Our Ref: IDL-1275-LLFA-01

RE: 25/01014/FP - Erection three storey building comprising 35no. retirement living apartments with associated communal areas, landscaping and parking following demolition of existing buildings. Land At Birchwood and Silverdale and Three Trees and Willow Close Old Charlton Road Hitchin Hertfordshire SG5 2AJ

We write in response to the Lead Local Flood Authority's holding objection letter regarding full application for the above scheme.

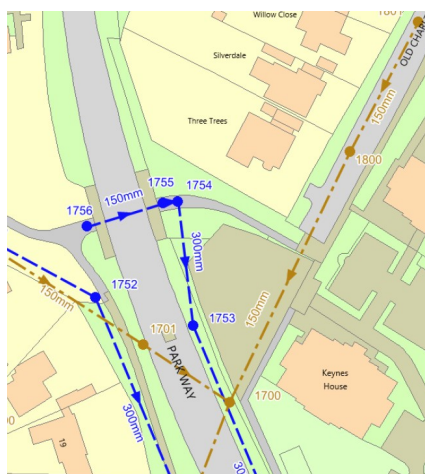
No evidence has been provided confirming consent from Anglian Water. The consent letter must specifically address the discharge of surface water from the site into their asset.

We acknowledge Anglian Water's objection regarding incomplete surface water hierarchy evidence and discharge rates. Please note that the drainage strategy report already addresses these points in detail:

- **Infiltration Feasibility:**

Crossfield Consulting conducted soakaway drainage testing in May 2024. The results confirm that the site mainly consists of fine-grained strata with low permeability and a high proportion of fines within sand and gravel horizons. Additionally, shallow groundwater was encountered at approximately 3.5–4.0 m depth. A falling head test further verified low-permeability conditions.

Conclusion: Soakaway drainage is not feasible.
